Final Product/Process Change Notification

Document #:FPCN22766X1

Issue Date:05 Mar 2020

Title of Change:	Update to FPCN22766X - Qualify ASE Kunshan as alternative assembly site for SOIC7.
Proposed First Ship date:	12 Jun 2020 or earlier if approved by customer
Contact Information:	Contact your local ON Semiconductor Sales Office or Marty.Paul@onsemi.com
PCN Samples Contact:	Contact your local ON Semiconductor Sales Office or <PCN.samples@onsemi.com>. Sample requests are to be submitted no later than 30 days from the date of first notification, Initial PCN or Final PCN, for this change. Samples delivery timing will be subject to request date, sample quantity and special customer packing/label requirements.
Additional Reliability Data:	Contact your local ON Semiconductor Sales Office or Shiela.Crosby@onsemi.com
Type of Notification:	This is a Final Product/Process Change Notification (FPCN) sent to customers. FPCNs are issued 90 days prior to implementation of the change. ON Semiconductor will consider this change accepted, unless an inquiry is made in writing within 30 days of delivery of this notice. To do so, contact PCN.Support@onsemi.com

OSPI: 3 Flag sizes

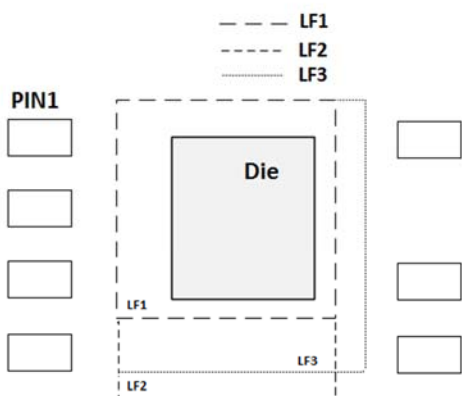
For assembly, the PN affected use 3 different LF (Lead frame) designs in OSPI. The flag (pad the die is attached to) has three sizes in OSPI. In ASEKS, there will be one flag size. BOM changes associated with this FPCN are shown here:

Assembly Site	OSPI	ASEKS
Lead Frame	3 LF designs	1 LF design
Die Attach	CRM-1076WB	EN-4900GC
Mold Compound	G600	CEL9240

OSPI: 3 Flag sizes

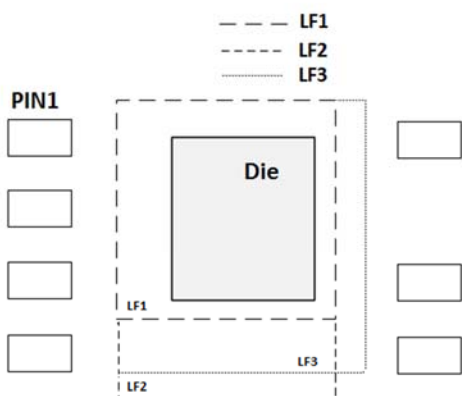
変更カテゴリ: アセンブリの変更		
変更サブカテゴリ: 材料の変更, 出荷/梱包/マーキング, 製造拠点の追加		
影響を受ける拠点:		
オン・セミコンダクター拠点:	外部製造工場 / 下請業者拠点:	
無し	ASEKS, China	
説明および目的:		
<p>この FPCN は、オン・セミコンダクターが、この FPCN にリストされている SOIC-7 製品の組立に関して、ASE Kunshan (昆山) ASEKS の認定が完了したことをお客様に通知するものです。これによって生産能力が拡大され、FPCN 承認サイクルが完了した時点で、該当の製品は ASEKS または先に承認済みの拠点である OSPI のいずれかからのデュアルソースとなります。</p> <p>リストされているすべての製品は、継続的に OSPI で検査されます。パッケージの寸法はすべて、既存のオン・セミコンダクターが公開しているパッケージケースアウトラインの規格内となります。</p> <p>組立においては、影響する PN には 3 つの異なる LF (リードフレーム) 設計が OSPI で使用されます。フラッグ (ダイを接着するパッド) には、OSPI では 3 つのサイズがあります。ASEKS では、フラッグのサイズは 1 つです。今回の FPCN に関連する BOM の変更を以下に示します:</p>		
組み立て拠点	OSPI	ASEKS
リードフレーム	3 LF designs	1 LF design
ダイ接着剤	CRM-1076WB	EN-4900GC
モールド・コンパウンド	G600	CEL9240
